Re: Lenox China Facility, Pomona, New Jersey

Re: Progress Report 9 for Ground Water Investigations of
Trichloroethylene (TCE) at Lenox China, Pomona, New Jersey.
Prepared by Geraghty and Miller, Inc. dated September 18,
1989.

RE: Summary Report On TCE Investigation and Proposed Ground Water
Remedial Design System for Lenox China

Re: Investigation of Trichloroethylene in Ground Water and
Proposed Remedial System, Lenox China Facility, Pomona,
Atlantic County

PILOT RECHARGE TRENCH

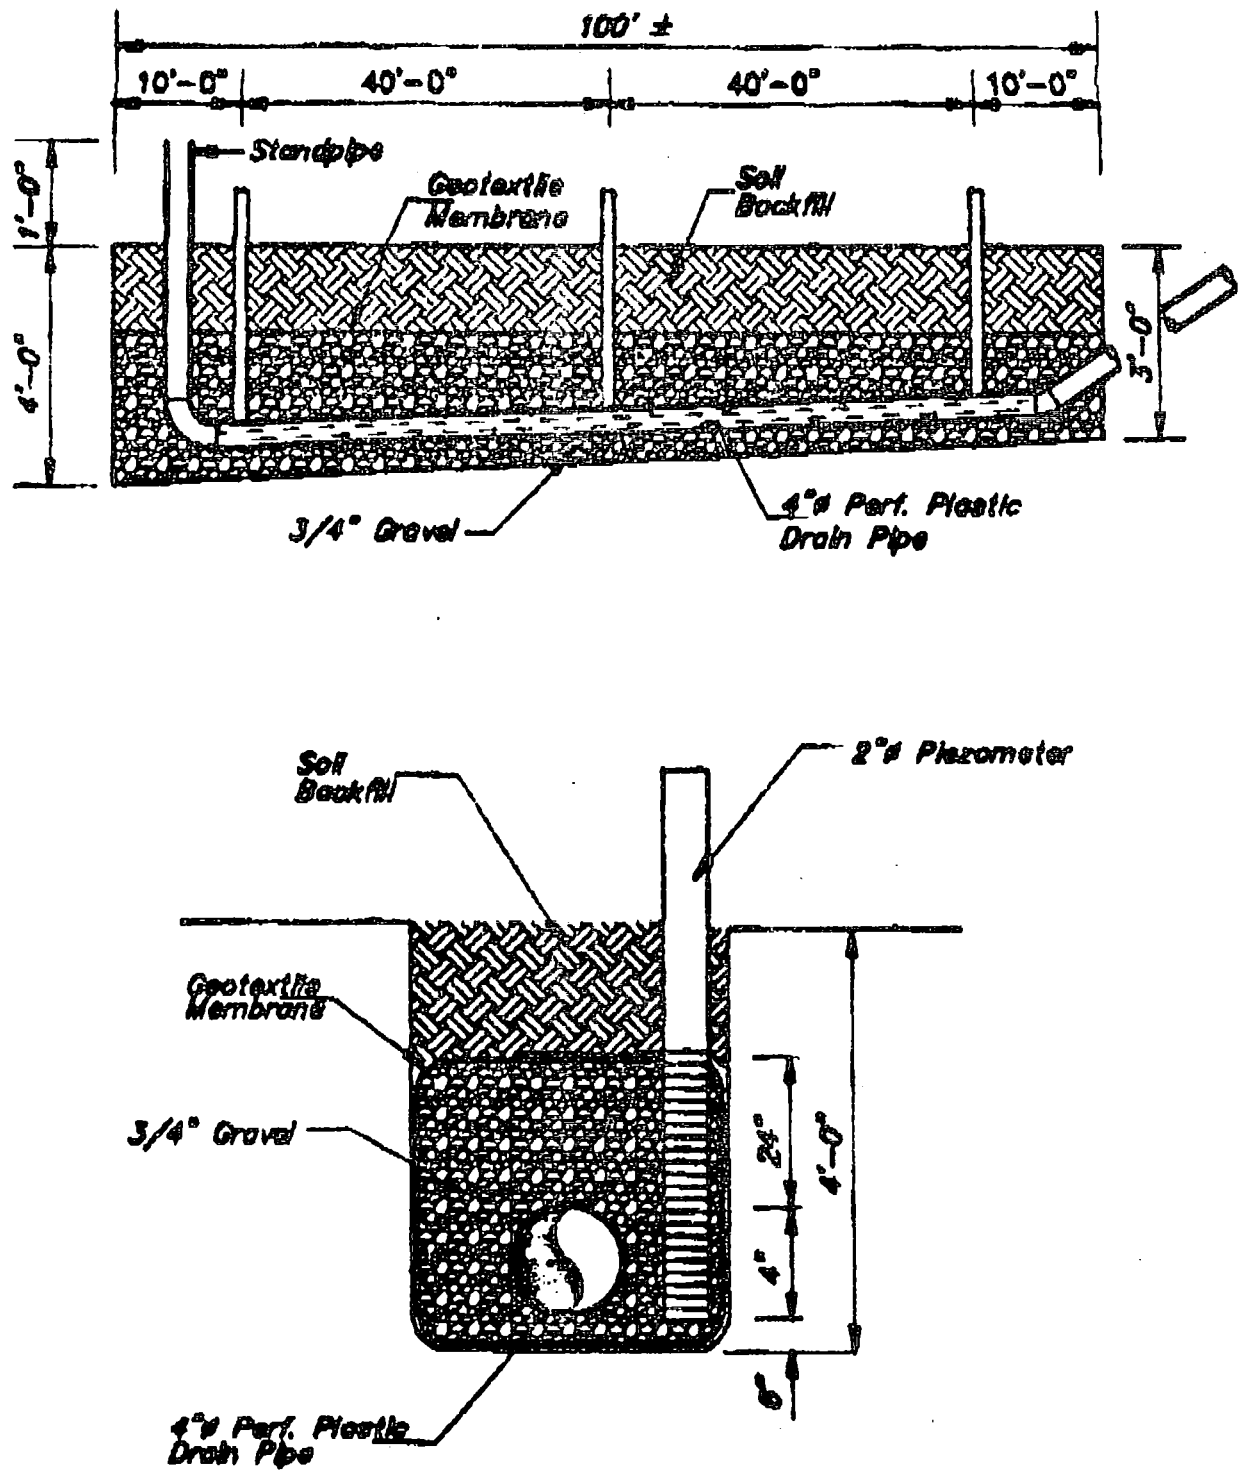
The pilot test will pump groundwater from existing Recovery Well RW1 through a Calgon Carbon Treatment Unit. The estimated TCE contamination at RW1 is 250 ppb and the treatment unit will provide TCE removal to less than 1 ppb. The treated water will be recharged to a 100 foot long pilot recharge trench - a copy of the design of the trench is attached to this letter. The trench will be located on Lenox property in front of its Pomona plant.

The New Jersey Department of Environmental Protection (Department) hereby allows Lenox Incorporated to conduct the proposed pilot test as requested in your letter of 24 June 1991. This letter authorizes the activities to be conducted at the Lenox China facility in Pomona, Atlantic County.

The pilot test will pump ground water from existing recovery well RW1 through a Calgon carbon treatment unit. The estimated trichloroethylene (TCE) concentration at RW1 is 250 parts per billion (ppb) and the treatment unit will provide TCE removal to less than 1 ppb. The treated water will be recharged to a 100 foot long pilot recharge trench. The trench will be located onsite, upgradient of the contaminant plume.

PROPOSED
MONITORING WELL LOCATIONS

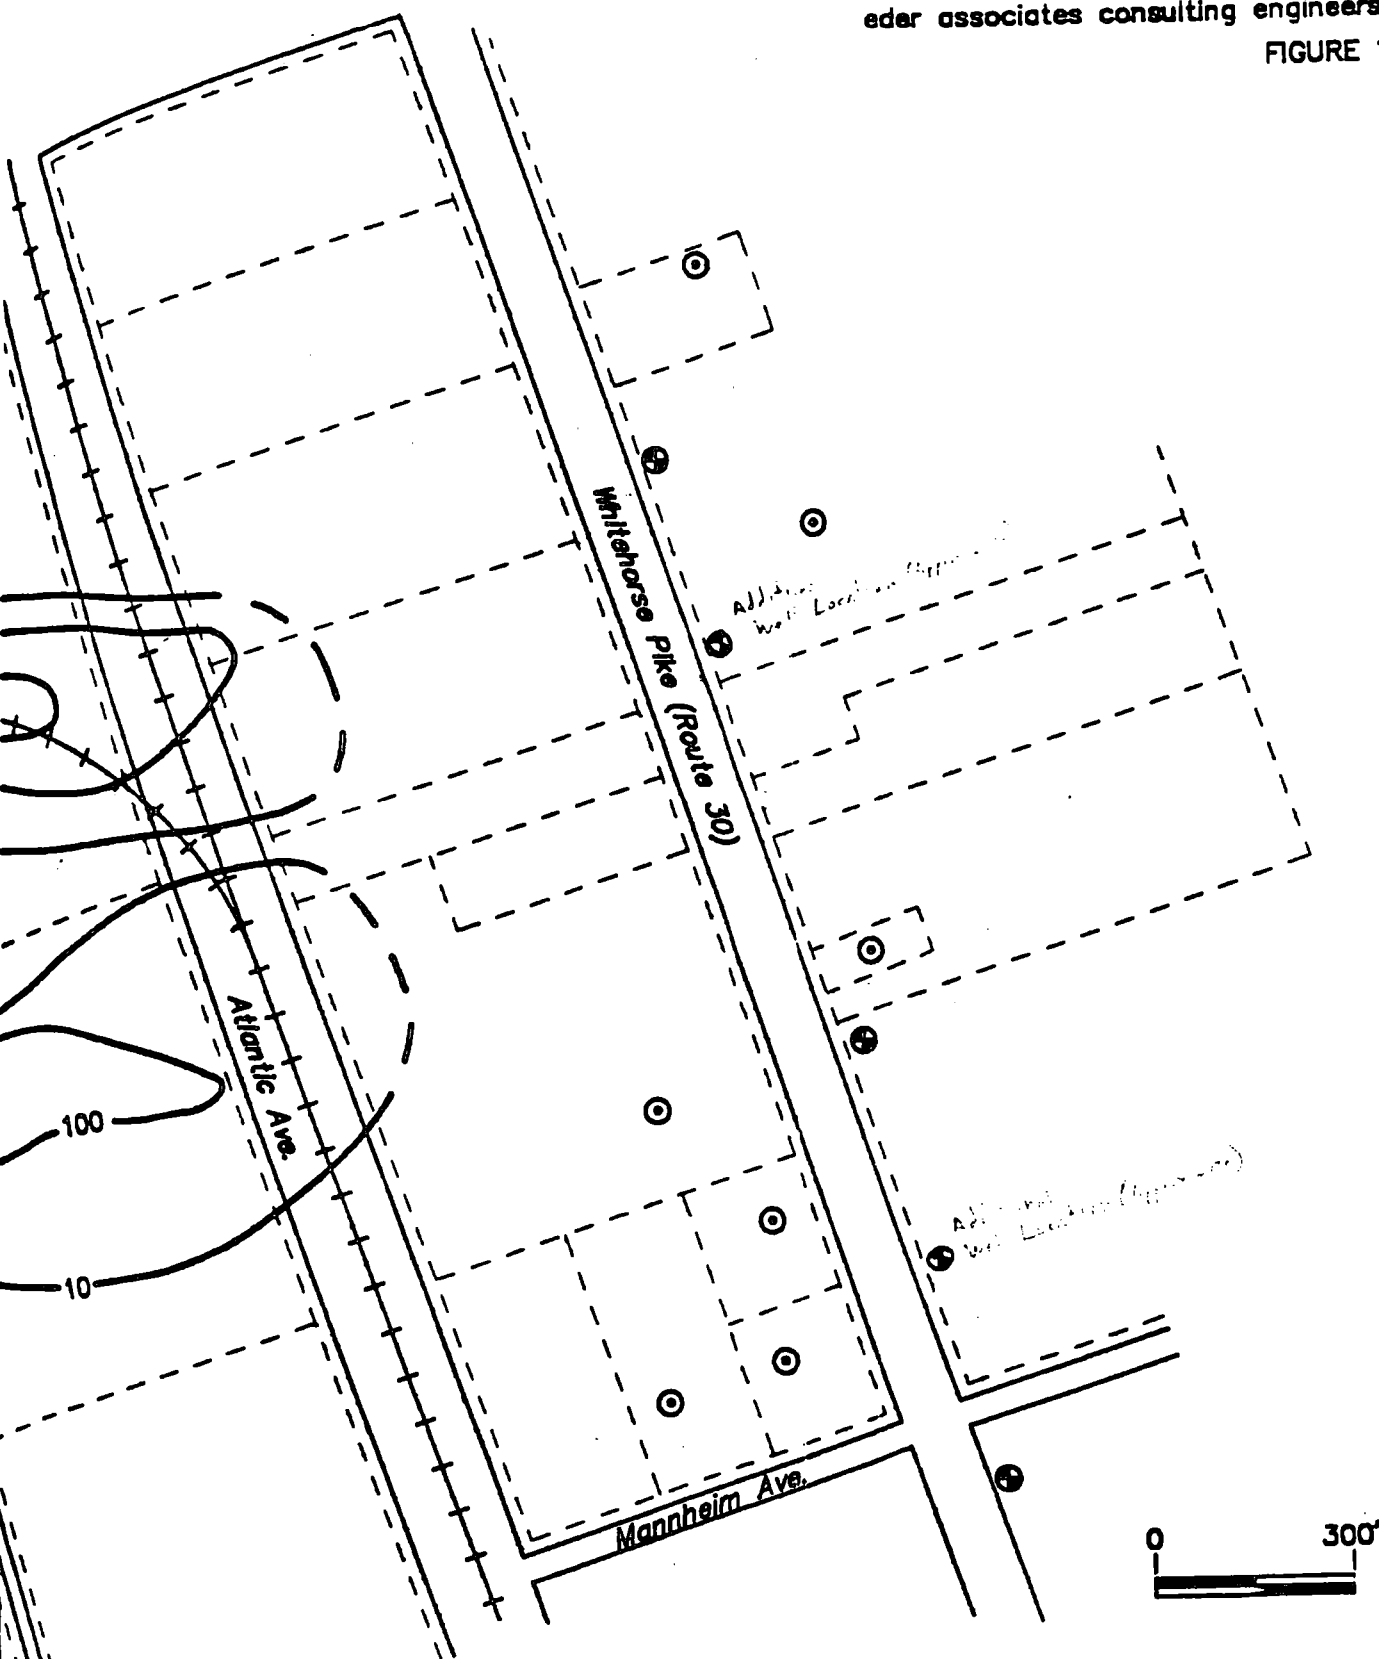
In regard to the proposed offsite ground water monitoring wells, the locations for the three wells are acceptable. The BGWPA also requires that two additional monitoring wells be installed along the northern side of Whitehorse Pike (Route 30) between the originally proposed wells (See map enclosure). The installation of the additional wells will provide better coverage of the area along Whitehorse Pike and will diminish the chances that contaminants will migrate between the wells undetected.

As part of the offsite monitoring program, Lenox must also attempt to obtain access to those domestic wells identified on the map that are located on the north side of Whitehorse Pike. These domestic wells will have to be monitored for the contaminants of concern.

With regard to the seven domestic wells shown on the Plan accompanying my August 11, 1992 letter, these wells are being monitored and Lenox has installed GAC filtering units. Two of the wells in previous sampling had reflected the presence of TCE and are being monitored monthly; the remaining five wells are being monitored quarterly. The results of the sampling are being sent to Daryl Clark of your Bureau.

Lenox is concerned about your requirement that two additional monitoring wells be installed along the northern side of Whitehorse Pike in the approximate locations that you had indicated. I respectfully request that you reconsider this requirement.

In my August 11th letter to you, Lenox had proposed installing three monitoring wells along the Whitehorse Pike east of the downgradient edge of the trichlorethylene (TCE) groundwater plume. The purpose of your request for the two additional wells was to diminish the chance that contaminants will migrate between the three wells undetected. We sincerely do

not believe that can happen. Lenox believes that the initial three-well proposal is a sound one and allows Lenox the flexibility to modify well locations based on actual field data.

The most recent groundwater monitoring data (May 1992) indicates that the plume is about 600 feet west of the east side of the Whitehorse Pike (Route 30) and at its widest point, the plume is approximately 1,000 feet wide. The three proposed monitoring wells will be spread over an approximate distance of 1,700 feet and the distance between wells will be 950 feet and 750 feet going from northeast to southeast.

The monitoring well spread is sufficient to encompass the plume width if it were to reach the Whitehorse Pike based on the accumulated data on the TCE plume. The plume width of 1,000 feet would tend to increase slightly to 1,200 or 1,500 feet maximum due to hydrodynamic dispersion in the aquifer as it moves downgradient. It is not possible for the plume to decrease in width if it were allowed to move downgradient by reason of this same aquifer property, dispersivity. Therefore, we believe that the proposed monitoring well spread leaves an ample margin of safety to encompass the plume width. Hydrogeologically, it is not physically possible for the plume to move between monitoring wells undetected since the wells are closer together than the maximum plume width upgradient of the proposed wells. Considering dispersivity, the increased plume width is inevitable under the hypothetical scenario of the plume reaching Route 30; therefore, the well spacing also provides an ample safety margin.
